Access Compliance Report

Public Rights-of-Way

(Curb Ramps)

Intersection ID: N/A	Main Street: S_BREVARD_ST	Cross Street: E_STONEWALL_ST	Location: E
ADA ID: 2B0D207E9356	Ramp Type: Perp	Initial Pass/Fail: Pass	Overall Compliance: No
Severity Score: 2.75			
Codes/Mitigation Info/Possible Solution		Field Measurements/Component Compliance

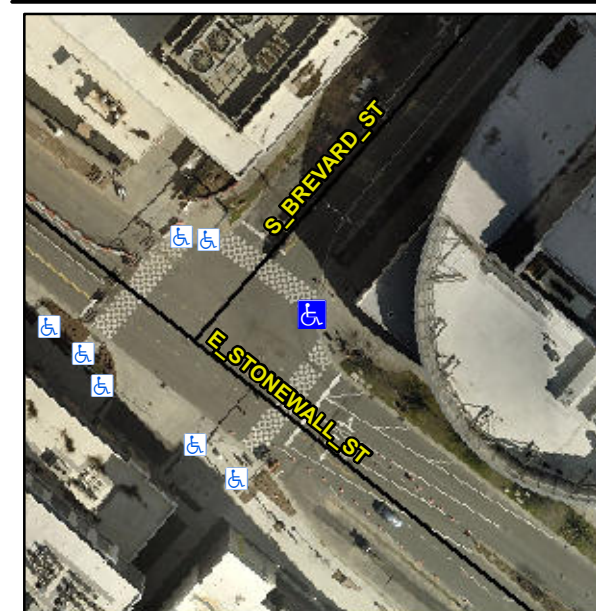
Possible Solutions:

Remove & Replace Entire Ramp.

Not Found, R304.2.2-Perp, R304.3.2-Para, R304.2.3
